SERVICE LETTER

Service Letter No. L288 December 16, 2021

TO: Owners and Operators of Lycoming TEO-540-C1A SUBJECT: Alternate Bolt Locking of Wastegate Solenoid valve

Figure 1

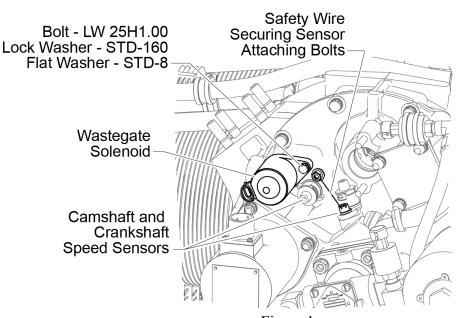
Lycoming has recently released Service Bulletin No. 648 adding the cleaning of the wastegate solenoid valve screen at scheduled oil change intervals on the TEO-540-C1A engine. This Service Letter announces that the repetitive need to remove and install safety wire on the solenoid valve attaching bolt can be eliminated by usage of lock washer P/N STD-160 in combination with Loctite® 243 or equivalent. When the subsequent procedure is followed it has been found to be an acceptable alternative process to installing safety wire in this location. If thread locker is not used, type 302/304 stainless steel safety wire (soft temper) per MS20995 must be used on the solenoid valve attaching bolt. The camshaft and crankshaft speed sensor bolts must continue to be safety wired in accordance with FAA Advisory Circular 43.13-1B Chapter 7-123, or international equivalent (Figure 1).

- 1. Visually inspect the bolt and internal threads for any damage or foreign material that could cause improper thread engagement. (Discard used lock washer and replace with new after each time its removed)
- 2. Leaving the first leading thread of the bolt free, apply a 360° bead of thread locker to the following 3-4 threads of the bolt. Do not allow the tip of the applicator to touch the bolt.
- 3. Complete the installation of the solenoid valve in accordance with the latest revision of Lycoming Service Bulletin No. 648. Tighten the bolt in accordance with Chapter 72-40 of the latest revision of the TEO-540-C1A Engine Maintenance Manual.
